QUALITY ASSURANCE - NONCONFORMANCE REPORT**Location:** T1 Pile Head Connection Plates (PHCP) 2E-1**Date:** 08-11-2007**Prime Contractor:** Kiewit/FCI/Manson-KFM-JV**NCR #190****Submitting Contractor:** Kiewit/FCI/Manson-KFM-JV**Type of problem:****Welding** **Concrete** **Other** **Welding:** **Curing:** **Procedural:** **Bridge No.** 34-0006 L / R**Joint fit-up:** **Coating:** **Other:** **Component:** T1 foundation footing**Procedural:** **Procedural:**

QUALITY ASSURANCE - NONCONFORMANCE REPORT

Subject: Response to KFM Letter No. 325 (Response to Inspection NCR's- SL 3351, 3352, 3376, and 3388)

KFM LETTER 325 – RESPONSE TO METS NCR’S 183, 184, 187, AND 190

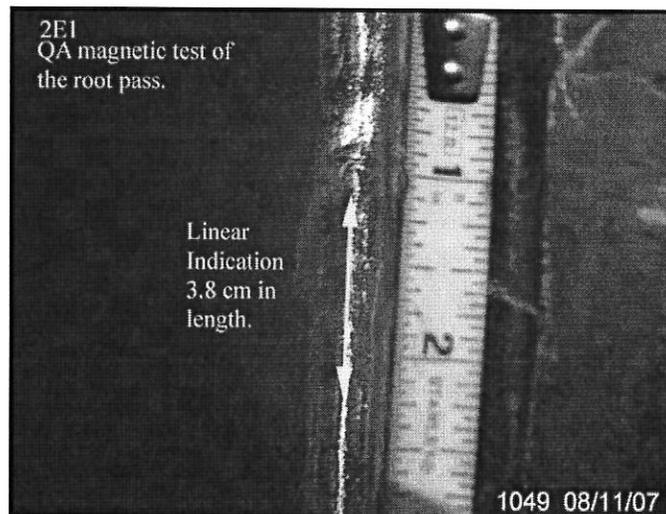
Description of Non-Conformance: KFM Quality Control Inspector, Gary Ehram, has overlooked multiple relevant Magnetic Particle (MT) indications while working on the E2/T1 project. Most recently this inspector overlooked a centerline linear indication in the root pass (3.8cm in length) of Pile Head Connection Weld 2E1. The indication was shown to the Quality Control Inspector and Mr. Ehram agreed the relevant indication was overlooked. The following digital photograph is an illustration of the indication discussed above.

**Applicable reference:** AWS D1.5 2002 Section 6.26.2.1 and 6.26.2.3**Who discovered the problem:** Quality Assurance Inspector Raymond Lara**Name of individual from Contractor notified:** ISI, QC Inspector Gary Ehram and QC Andrew Coffman**Time and method of notification:** 08/11/07 at approximately 1130 via verbal notification.**Name of Caltrans Engineer notified:** Caltrans Assistant Structures Representative, Thanh Le**Time and method of notification:** Verbal notification on 8-11-07**QC Inspector's Name:** ISI QC Inspector, Gary Ehram

Contractor's proposal to correct the problem: Removed indications by grinding before welding commenced.

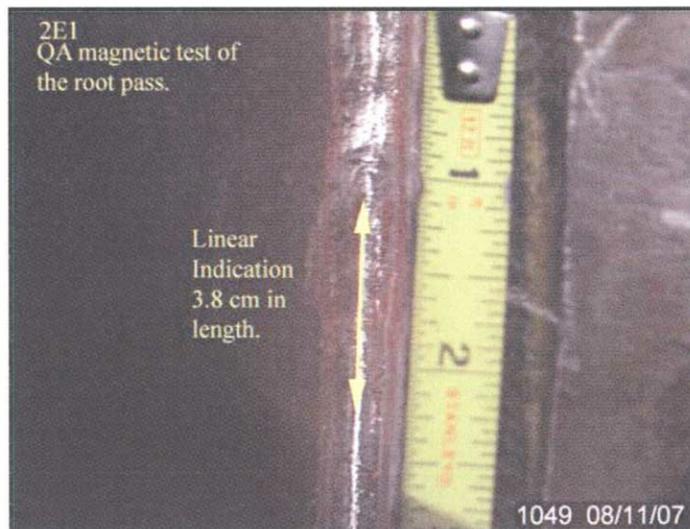
Description of Non-Conformance: KFM Quality Control Inspector, Gary Ehram, has overlooked multiple relevant Magnetic Particle (MT) indications while working on the E2/T1 project. Most recently this inspector overlooked a centerline linear indication in the root pass (3.8cm in length) of Pile Head Connection Weld 2E1. The indication was shown to the Quality Control Inspector and Mr. Ehram agreed the relevant indication was overlooked. The following digital photograph is an illustration of the indication discussed above.

Applicable reference: AWS D1.5 2002 Section 6.26.2.1 and 6.26.2.3**Who discovered the problem:** Quality Assurance Inspector Raymond Lara**Name of individual from Contractor notified:** ISI, QC Inspector Gary Ehram and QC Andrew Coffman**Time and method of notification:** 08/11/07 at approximately 1130 via verbal notification.**Name of Caltrans Engineer notified:** Caltrans Assistant Structures Representative, Thanh Le**Time and method of notification:** Verbal notification on 8-11-07**QC Inspector's Name:** ISI QC Inspector, Gary Ehram

Contractor's proposal to correct the problem: Removed indications by grinding before welding commenced.
